Bid 627
New HVAC Modernization Project for (Both) Oxnard and Pacifica High Schools

BID CLARIFICATION ADDENDUM #3

Dated: August 25th, 2020

DRAWING NUMBER: **S2.13**

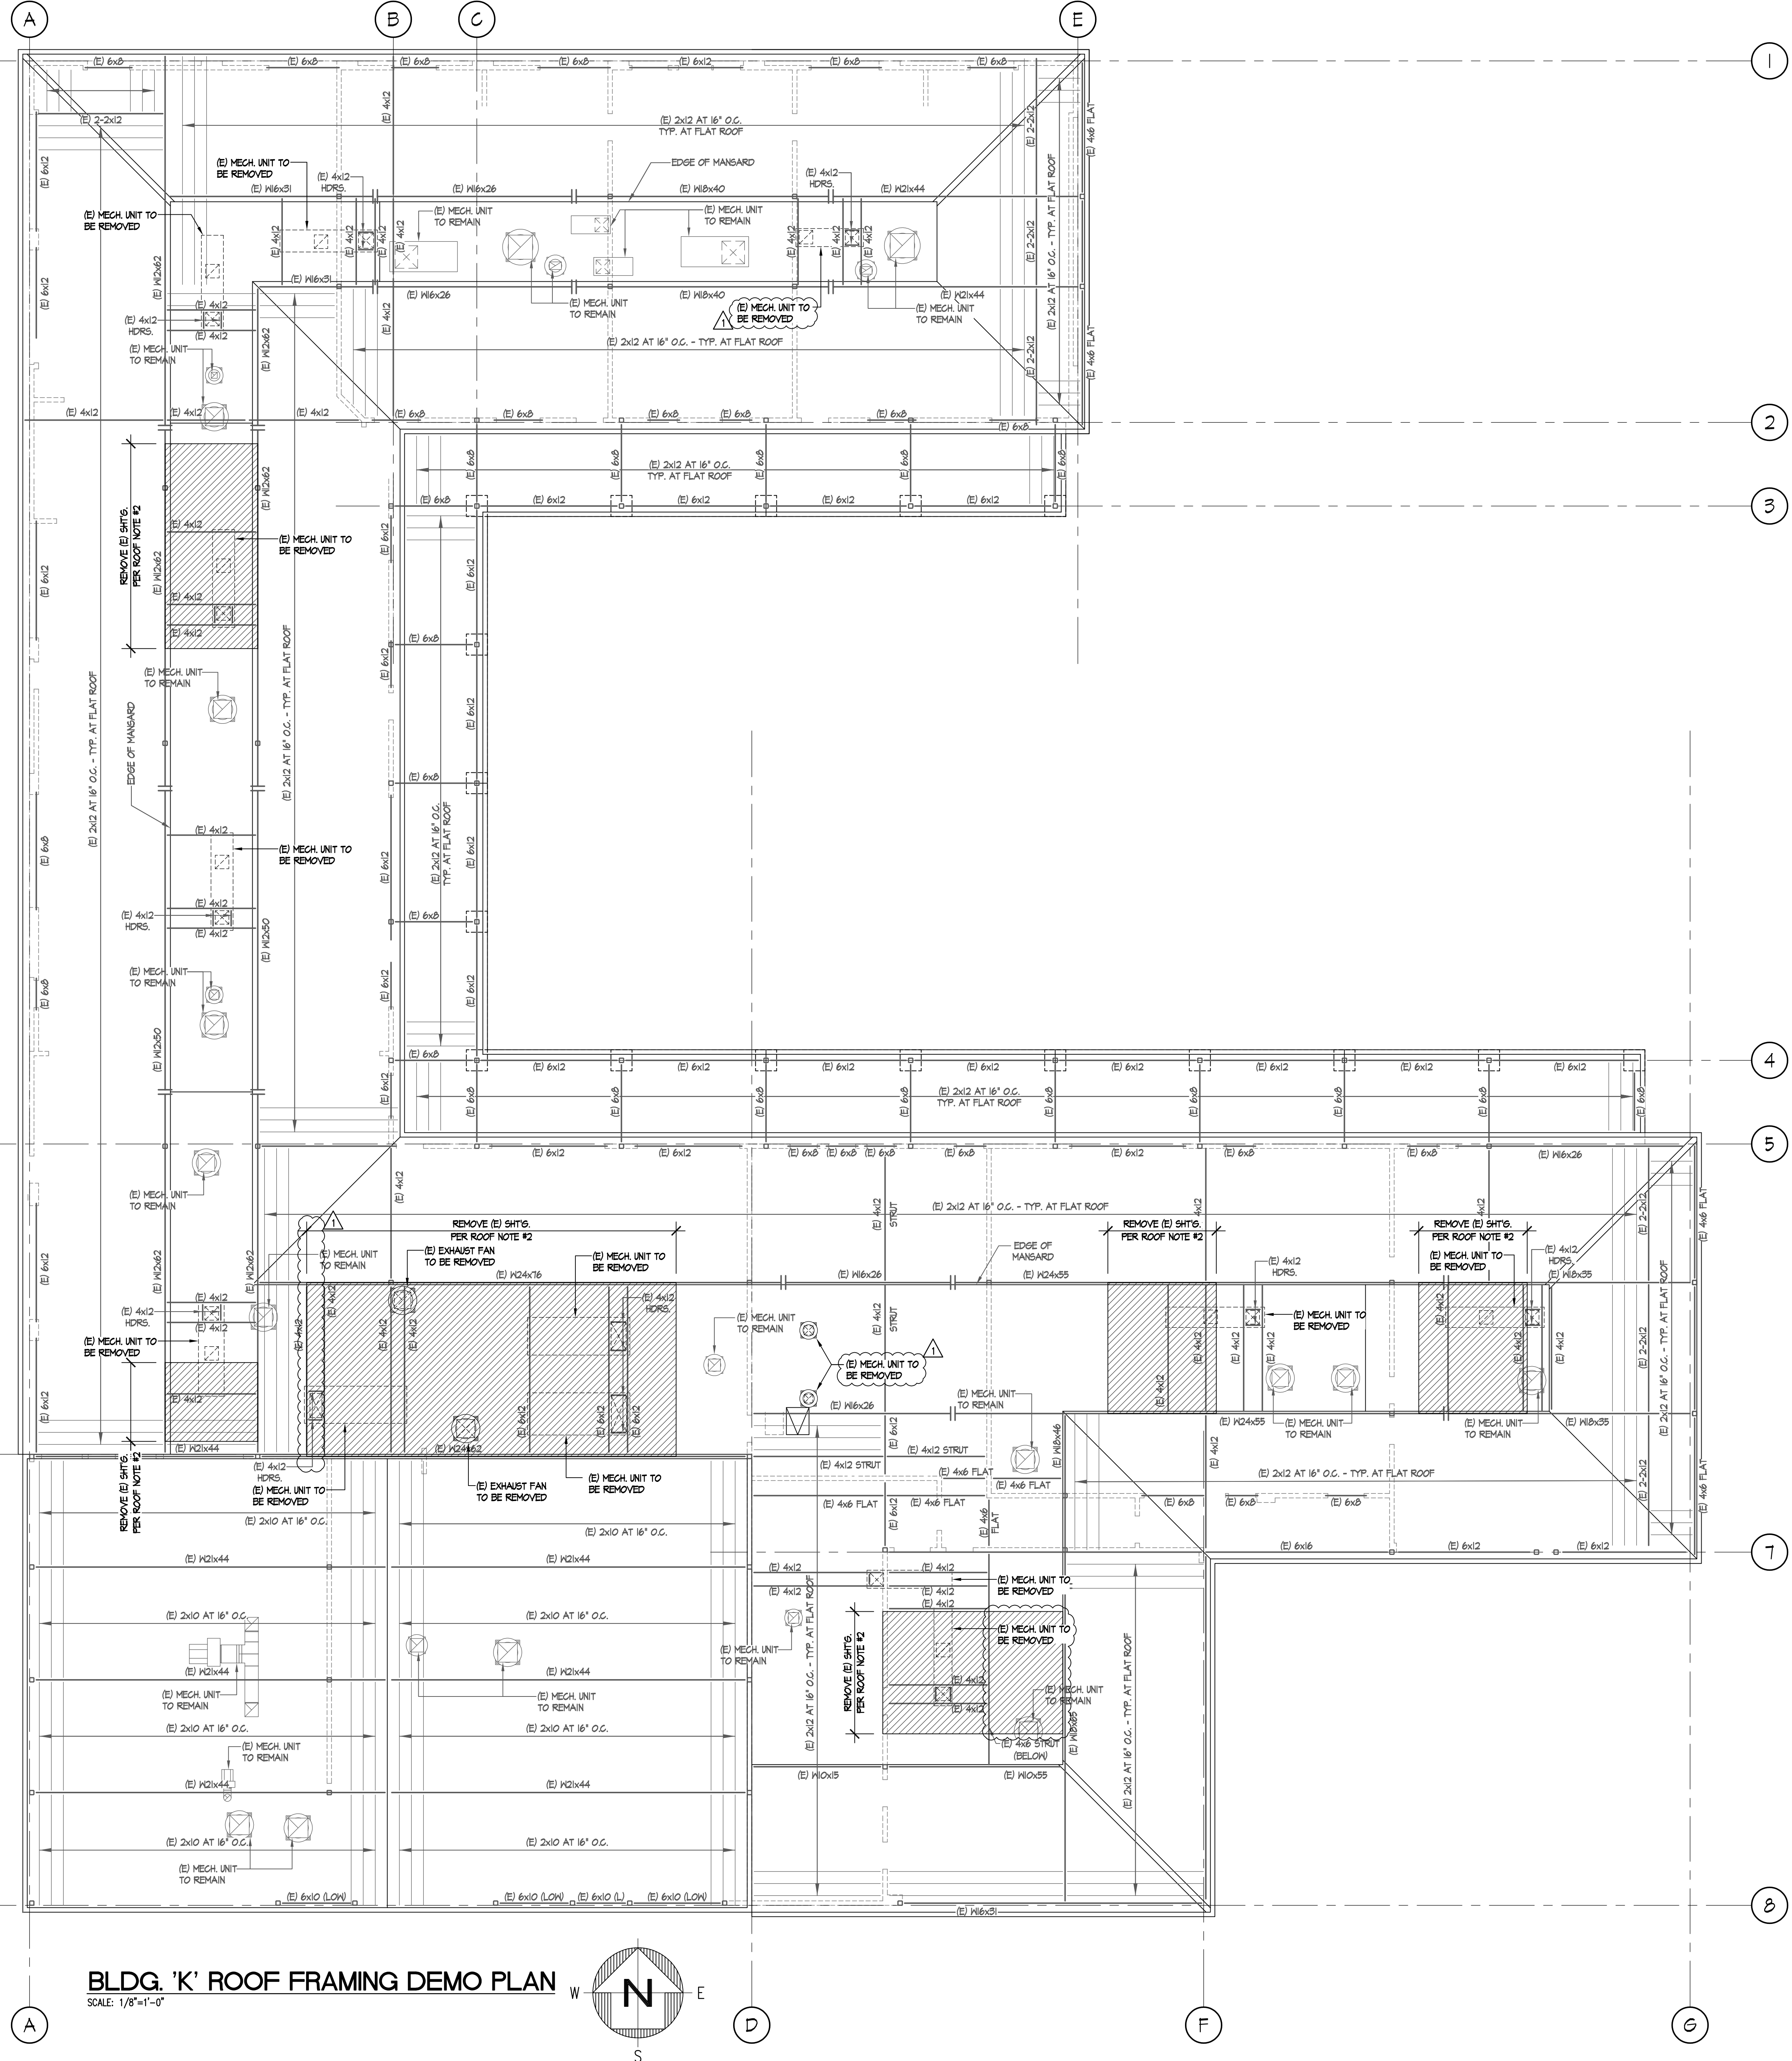
A. Replace DSA approved Drawing S2.13 in its entirety with the attached revised Drawing S2.13.

DRAWING NUMBER: **MPK3.1**

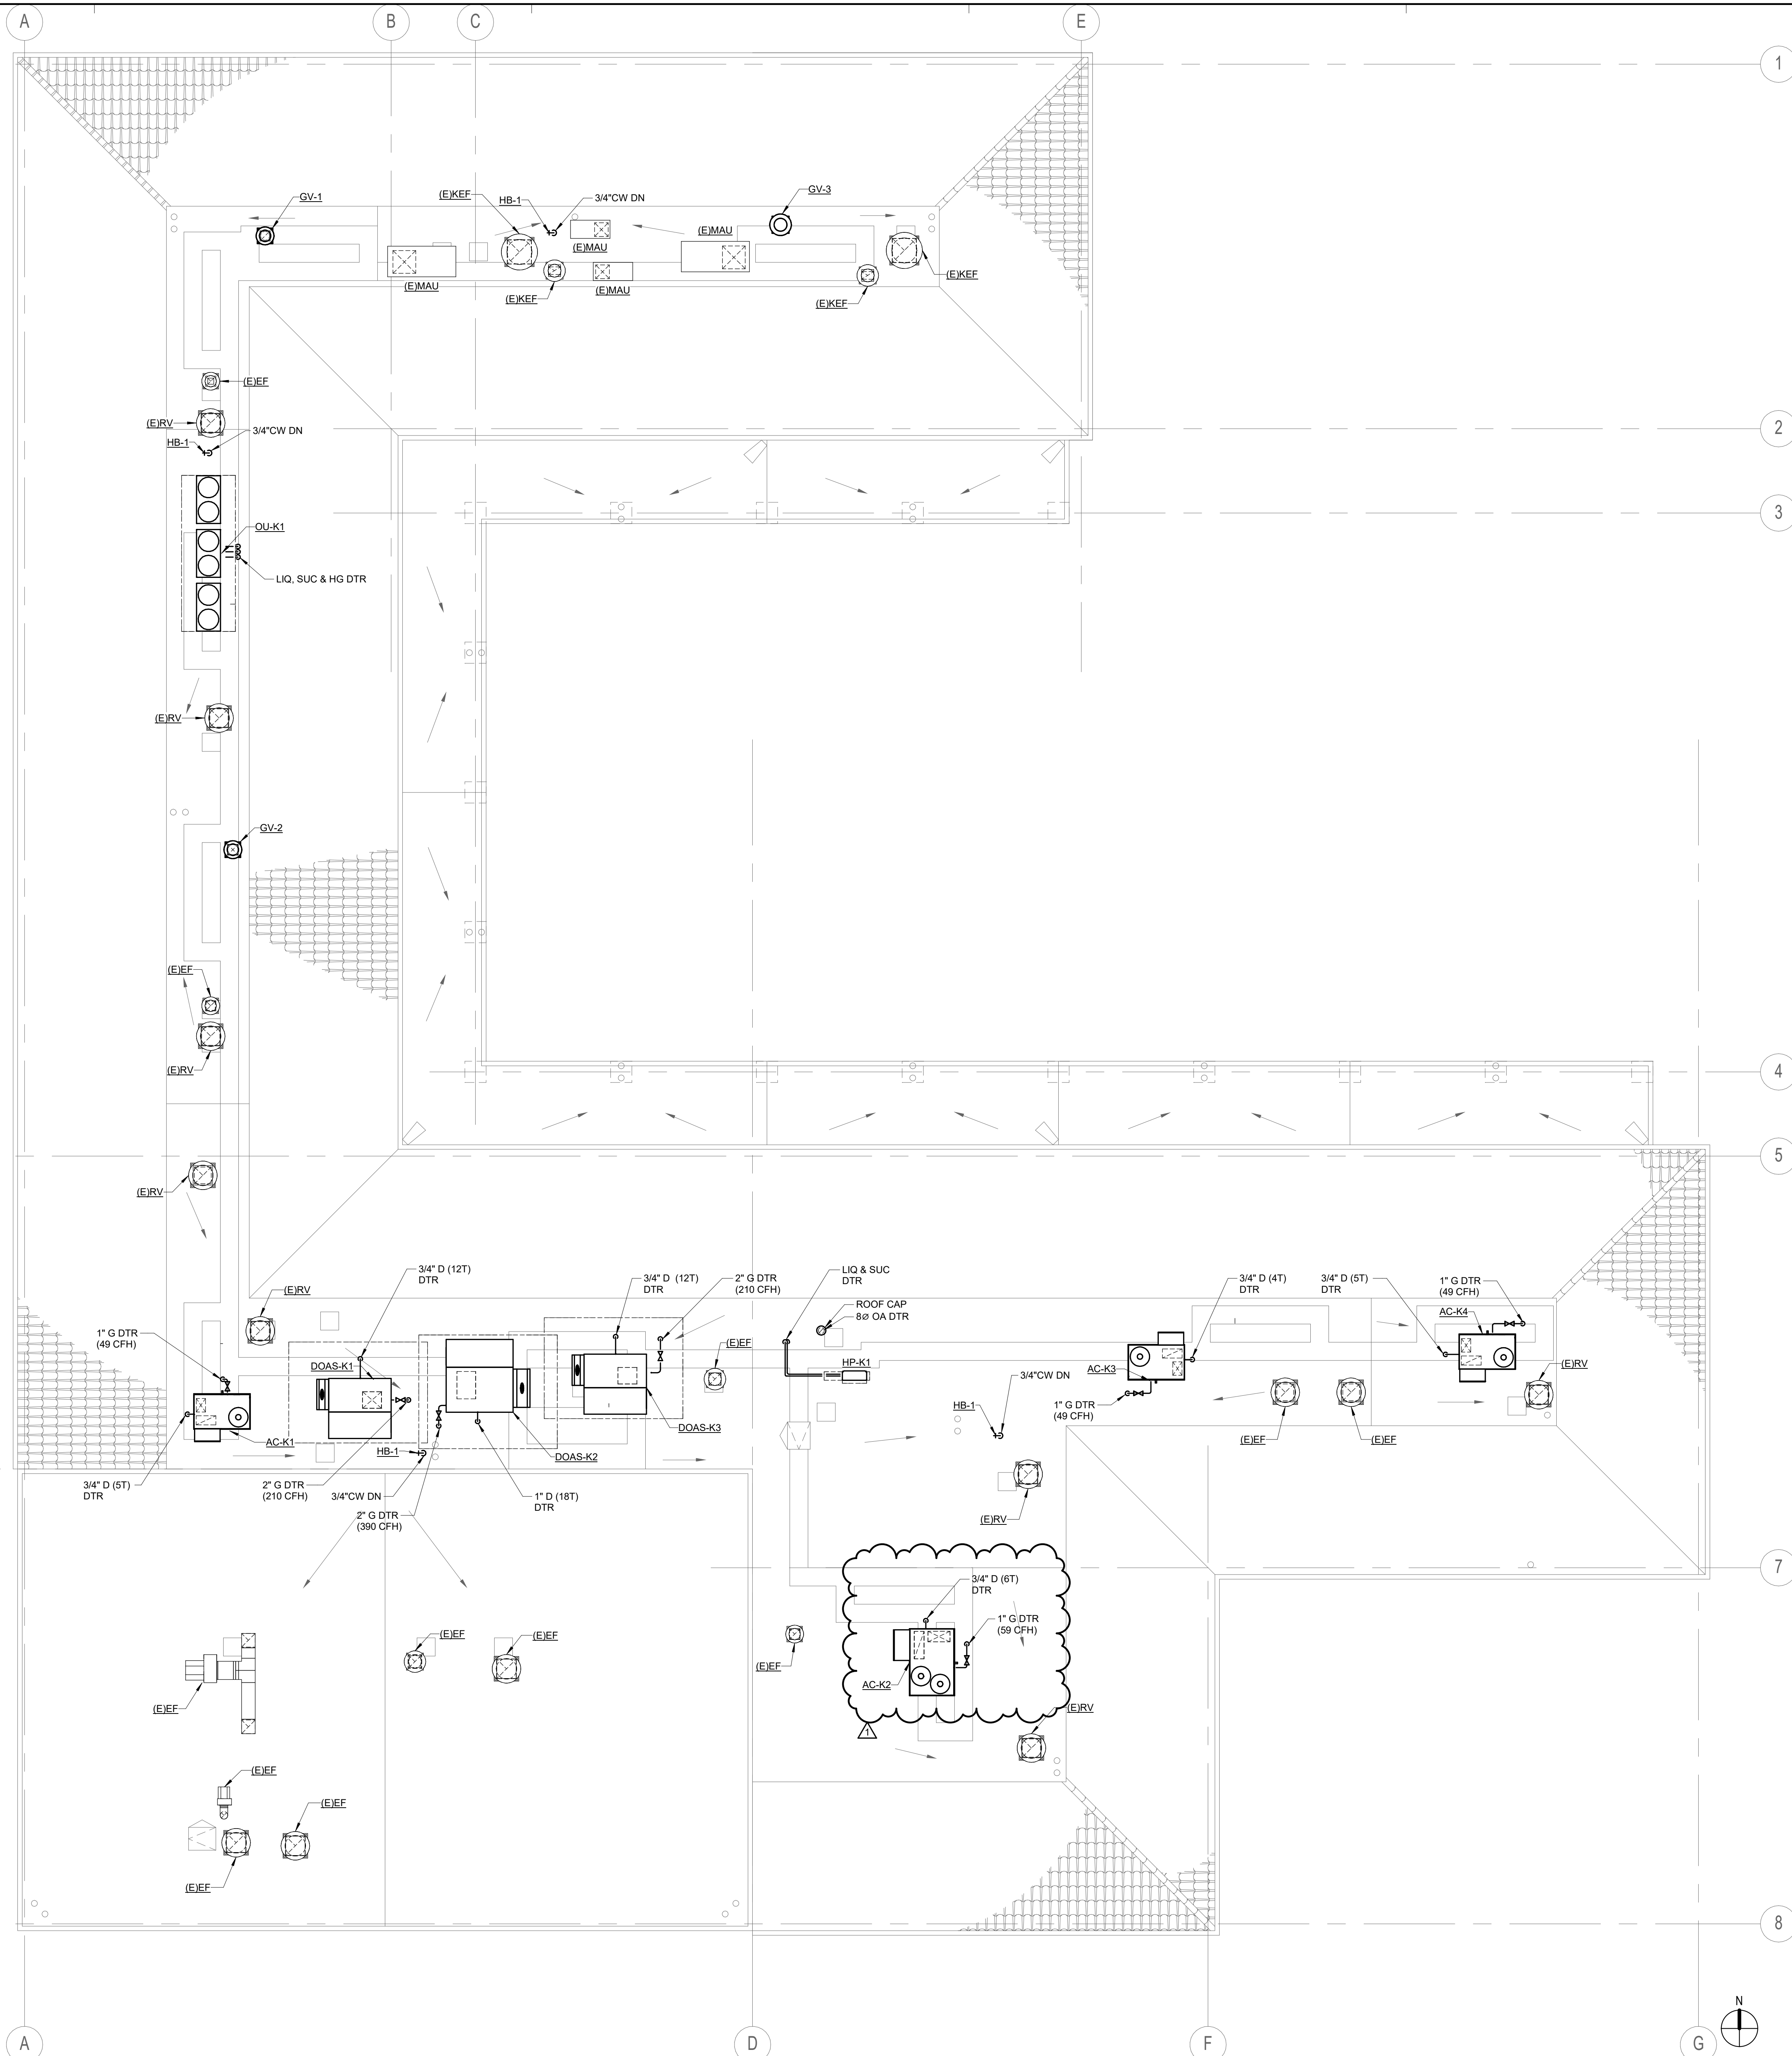
A. Replace DSA approved Drawing MPK3.1 in its entirety with the attached revised Drawing MPK3.1.

DRAWING NUMBER: **EB3.1**

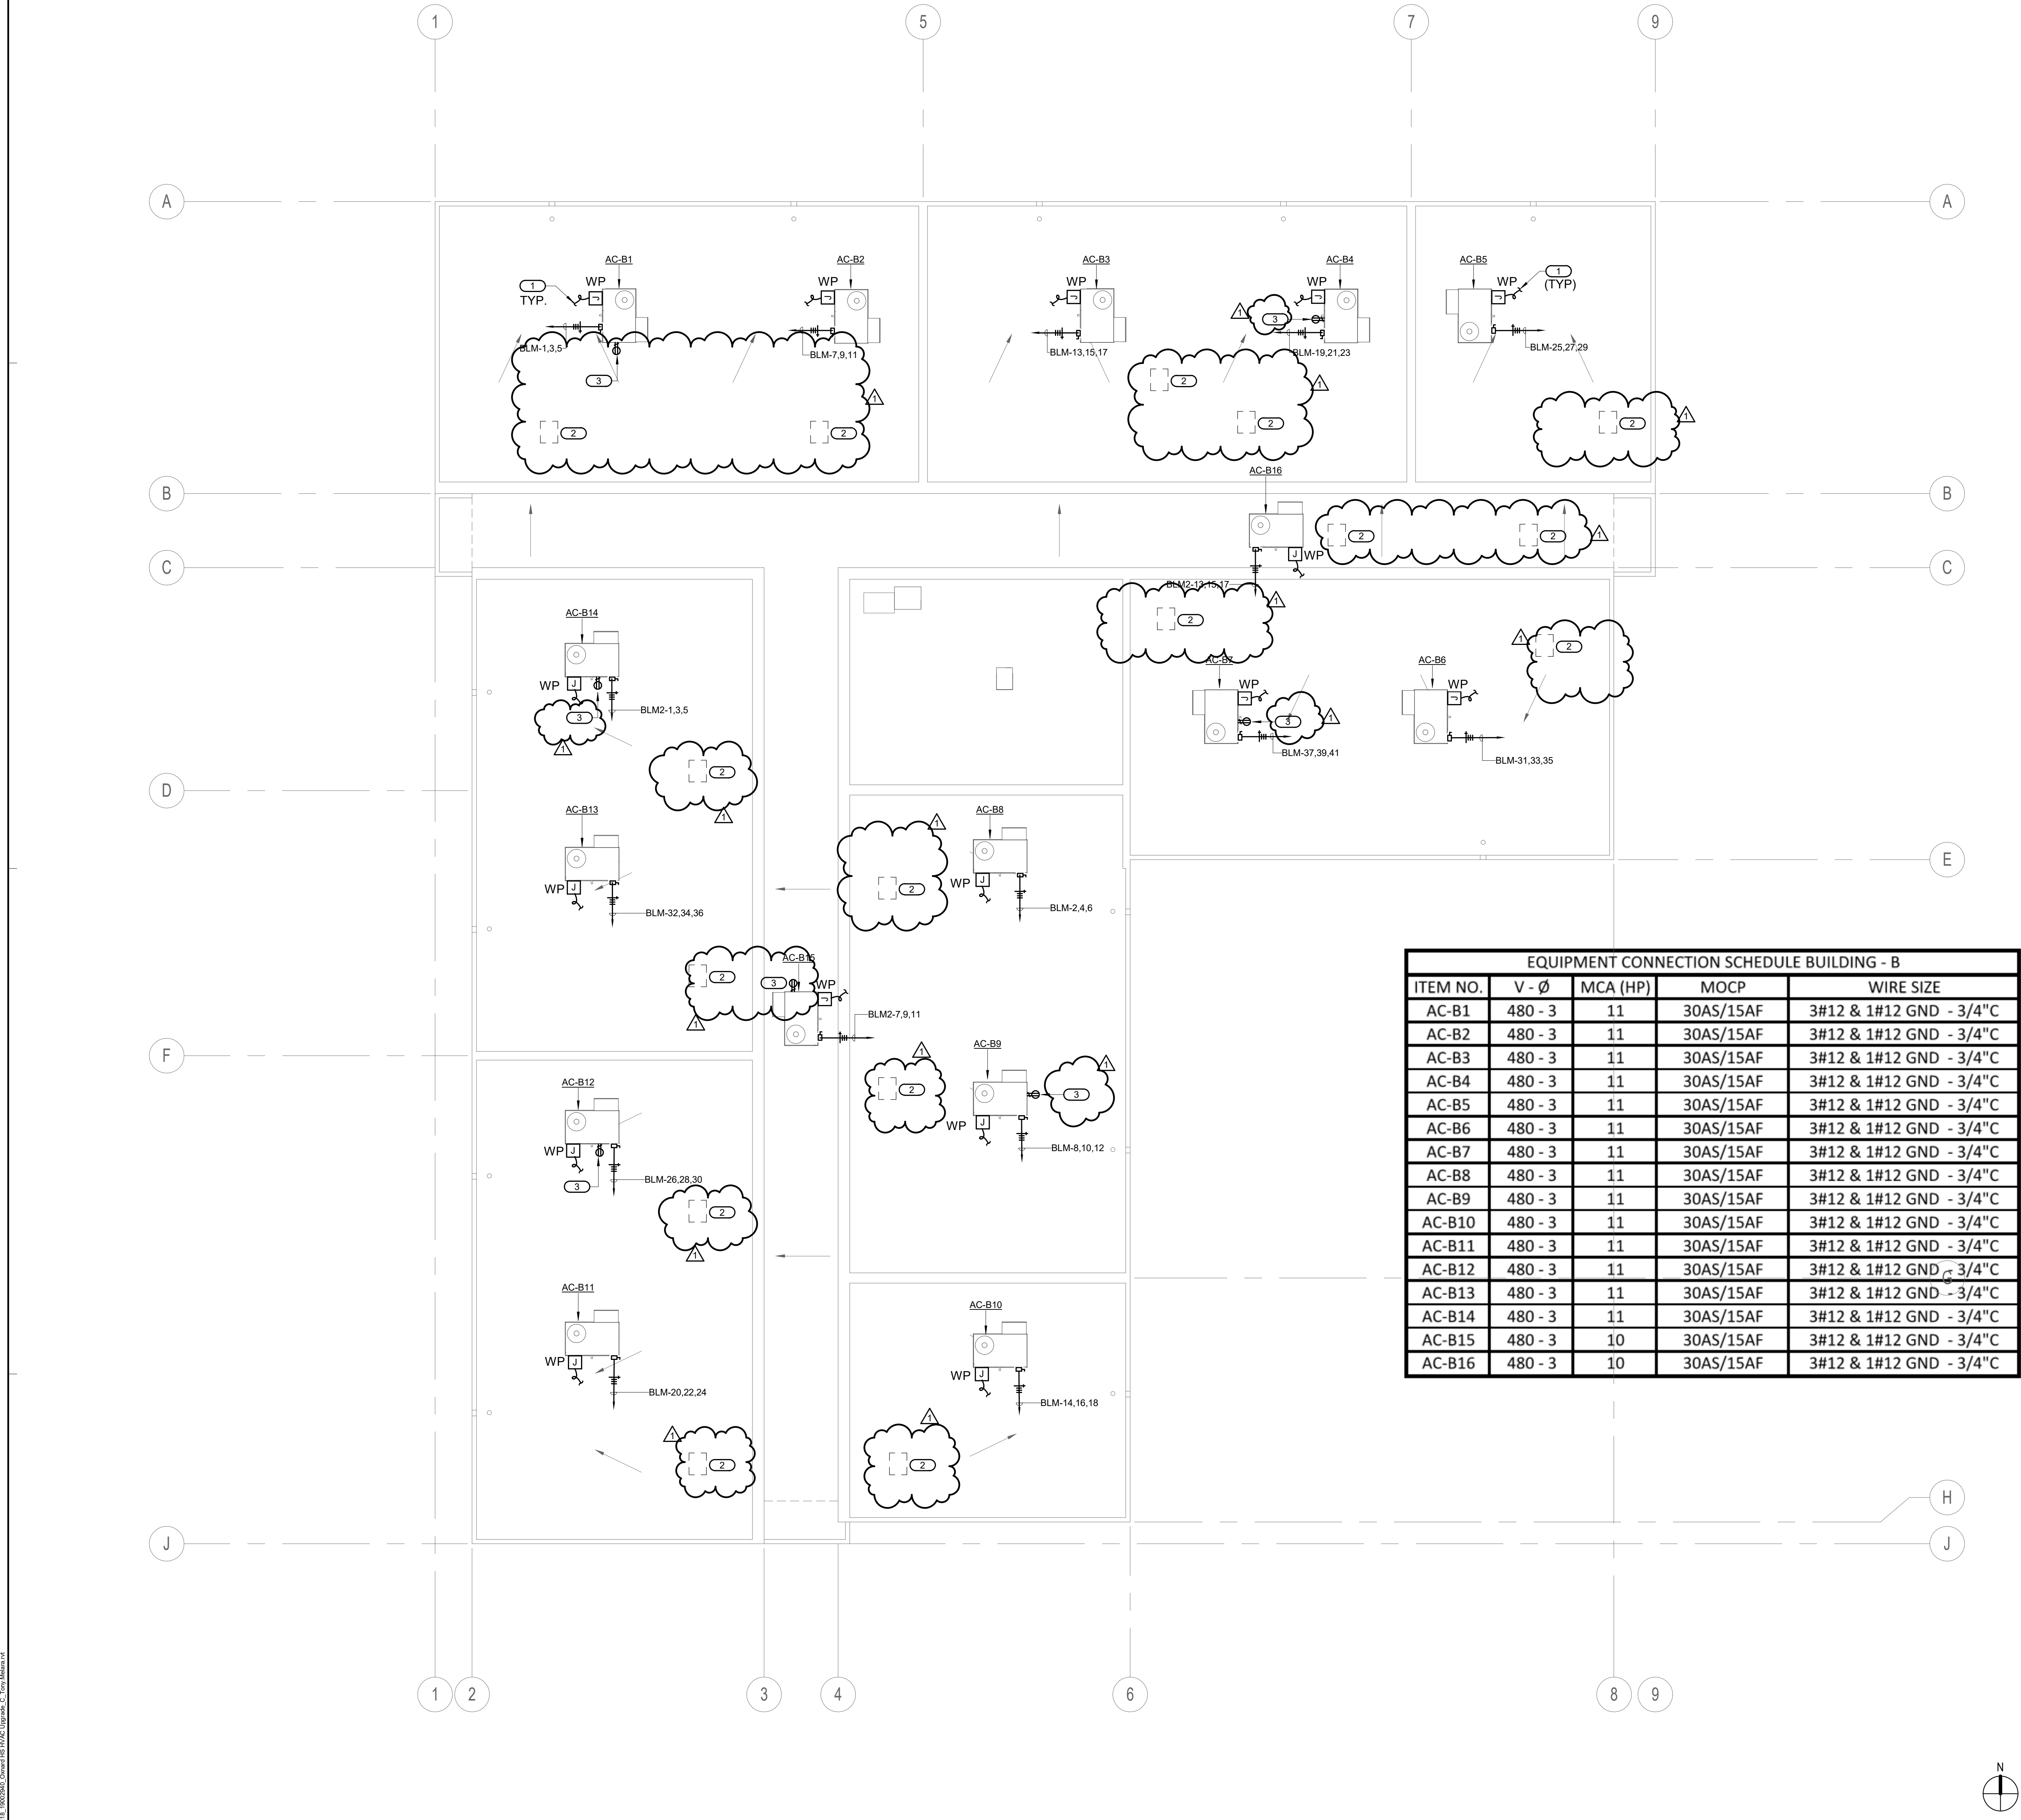
- a. Added Detail 2, CONDUIT ROOF PENETRATION.
- b. Added demolition clarification.
- c. Added General Notes 1, 2, and 3.
- d. Added Keyed Notes 2 and 3.
